UNITED STATES PATENT AND TRADEMARK OFFICE

APPLICATION NO.	FILING DATE	FIRST NAMED INVENTOR	ATTORNEY DOCKET NO.	CONFIRMATION NO.
10/528,706	11/08/2005	Patrick Beguery	266484US6XPCT	2039
22850	7590	02/06/2009		
OBLON, SPIVAK, MCCLELLAND MAIER & NEUSTADT, P.C. 1940 DUKE STREET ALEXANDRIA, VA 22314				
EXAMINER ESSEX, STEPHAN J				
ART UNIT		PAPER NUMBER		
4111				
NOTIFICATION DATE		DELIVERY MODE		
02/06/2009		ELECTRONIC

Office Action Summary

DETAILED ACTION

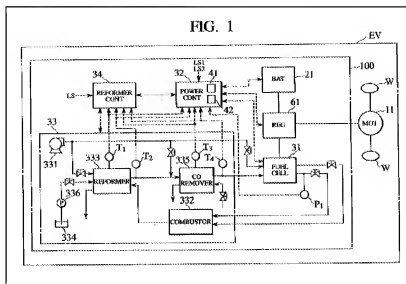
Regarding claim 10, Kobayashi teaches an electric energy recovery system in a motor vehicle (electric vehicle EV), containing a fuel cell (31) that feeds the electric motor (11) and electrical equipment and is supplied with fuel of hydrogen (hydrogen-rich gas), by a reformer (333), a fuel flow of which is controlled in accordance with electricity consumption of the electric motor, and which temporarily produces excess fuel when

a) a balance during which a potential electric power that fuel cell is capable of instantaneously supplying is calculated in accordance with the fuel flow produced by the reformer (reformer 333) (see paragraphs 30, 40, figure 1).

Regarding claim 13, Kobayashi teaches that the remaining portion of excess fuel is burned off (combustor 332) (see paragraph 34, figure 1 above).

Regarding claim 15, Kobayashi teaches the use of electric batteries (secondary battery 21) for energy storage (see paragraphs 14 and 26, figure 1 above).

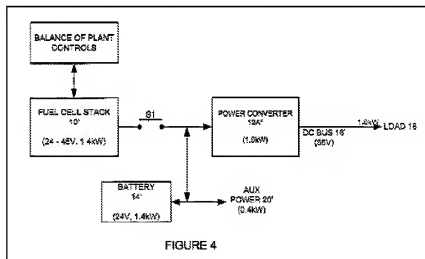
Jungreis teaches that is known in the art to calculate excess electric power as the difference between potential electric power and the sum of electric powers consumed (load 18) (see paragraph 16, figure 4). It is therefore implied there are means for estimating the sum of electric powers consumed.

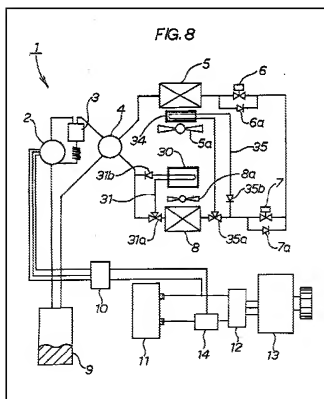
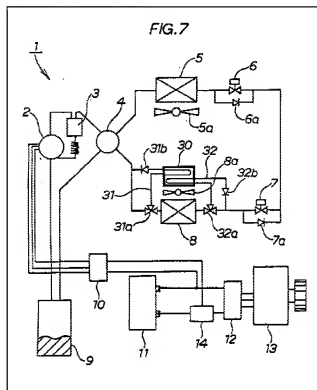
Seto teaches a method for recuperation braking (regenerative brake means) activated when the electric power consumed by the motor is nil (when decelerating the vehicle), the electric motor being capable of operating as a generator, and during which the electric power capable of being produced by the electric motor (regenerative electrical energy) is estimated and then added to the excess electric power (excess regenerative electrical energy) (see col. 4, lines 21-37).

Seto teaches energy storage in the form of a heat accumulator (heat accumulating means 30, 34) in which the excess electric power (excess regenerative power) is stored in a form of heat energy by a compression cooling system (compressor 2) (see abstract, col. 5, lines 55-58, col. 6, lines 1-8, figures 7 and 8).

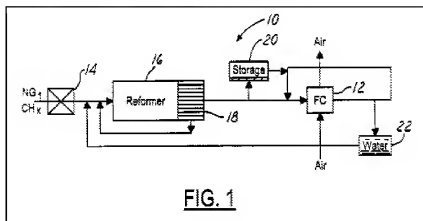
Singh teaches the storing of excess fuel in a tank (storage container 20) (see col. 2, lines 48-53, figure 1).
